SENATE BUSINESS & INDUSTRY
EXHIBIT NO. 6
DATE 1/21/05
BILL NO. SB 211

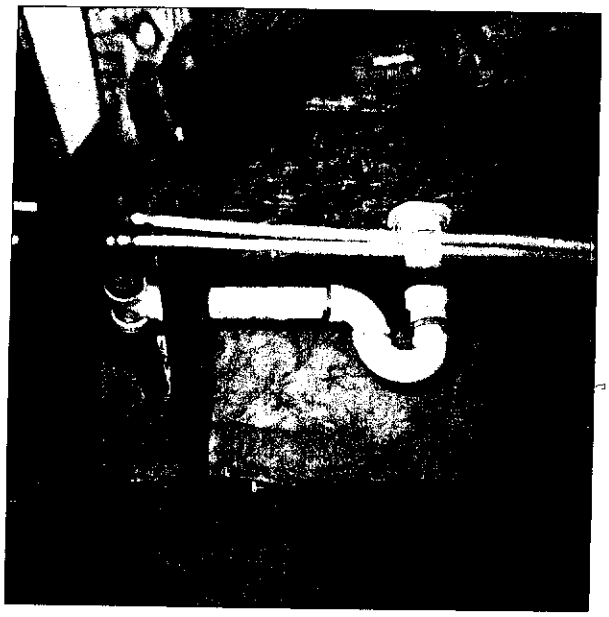
SHOWER DRAIN IMPROPERLY VENTED
VENT IS ON THE SAME LEVEL AS THE
DRAIN SO VENT WILL GET PLUGGED AND
DRAIN WON'T WORK RIGHT. DRAIN SHOULD
ALSO BE 2". THIS IS 1½"

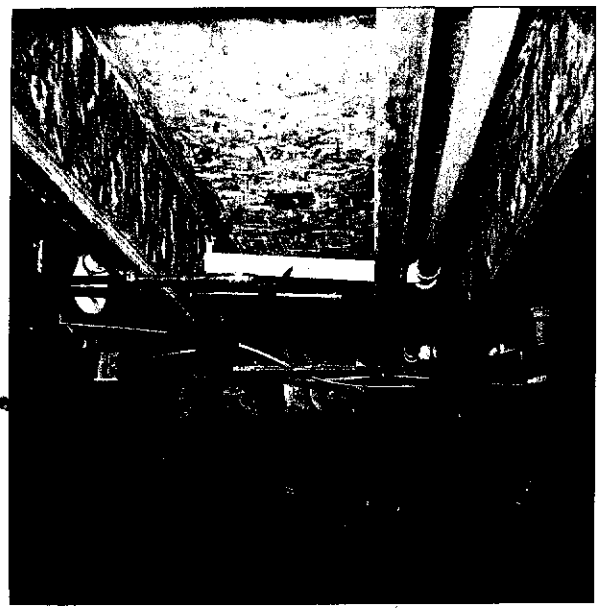
WHIRLPOOL TUB DRAIN IS NOT VENTED
AT ALL. SHOULD ALSO BE 2". THIS
IS 1½. ALSO NOTICE PIPE IS NOT
SUPPORTED FOR FULL LENGTH OF FLOOR
JOIST.

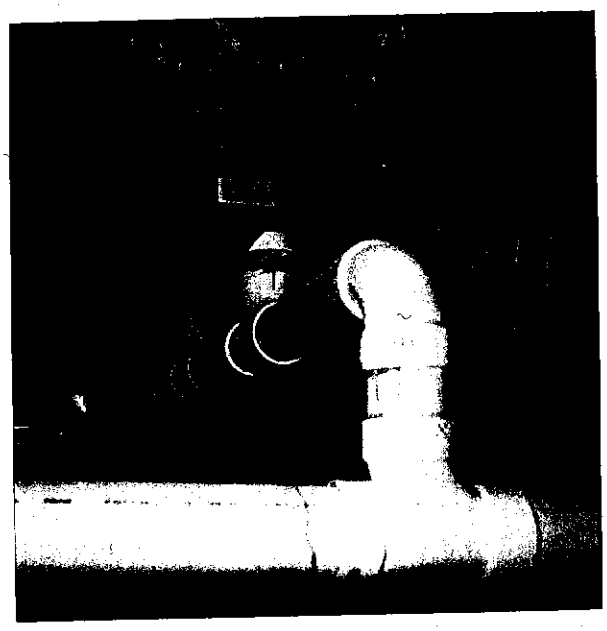
2 TOILETS BACK TO BACK IMPROPERLY VENTED. THEY ALSO TIE INTO MAIN DRAIN WITH A TEE. IT SHOULD BE A WYE OR SWEEP FITTING

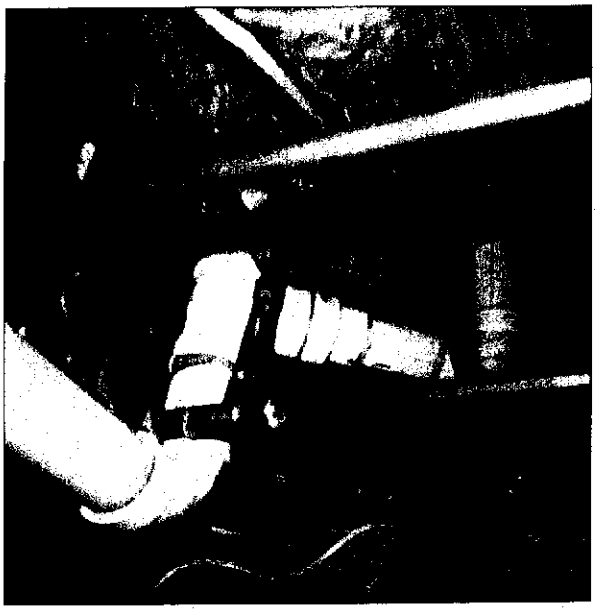
THIS IS A WASHING MACHINE DRAIN. THE VENT IS TIED IN BELOW THE FLOOR. IT SHOULD BE TIED IN ABOVE THE FLOOR.

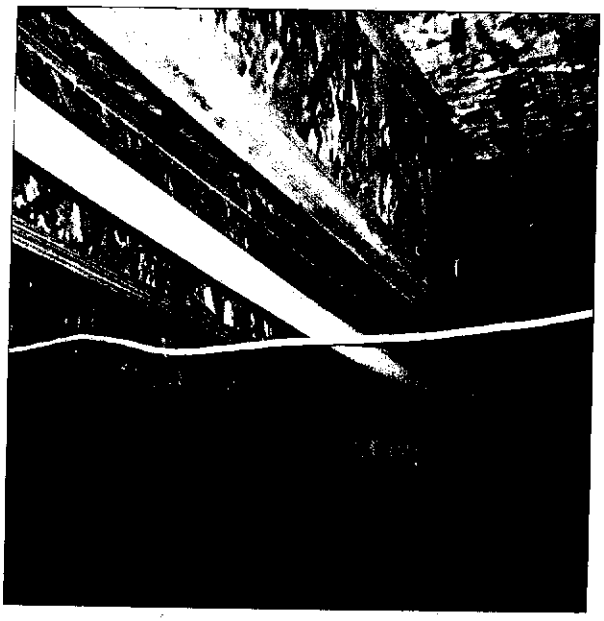
KITCHEN SINK DRAIN. WAS NOT SUPPORTED IN 10' - SHOULD BE EVERY 4'. IT WAS BOWED WAY DOWN BELOW THE FLOOR JOIST. IT TOO SHOULD BE 2". THIS ONE IS 1½"

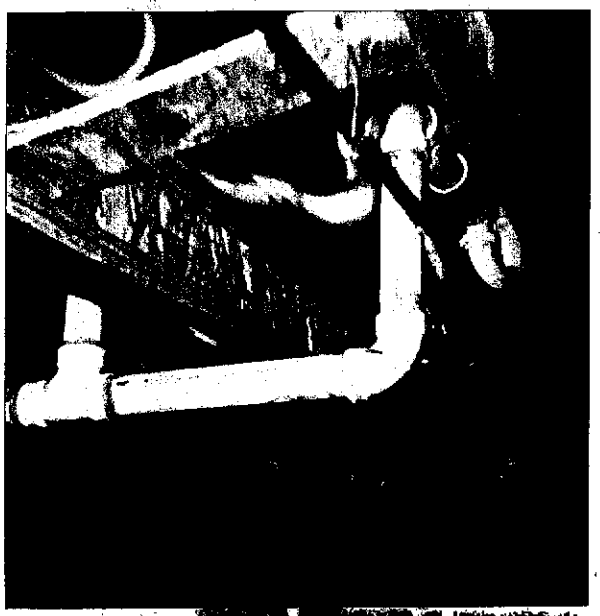
TUB DRAIN IS IMPROPERLY VENTED. IT SHOULD ALSO BE PIPED IN 2", THIS IS 1½".
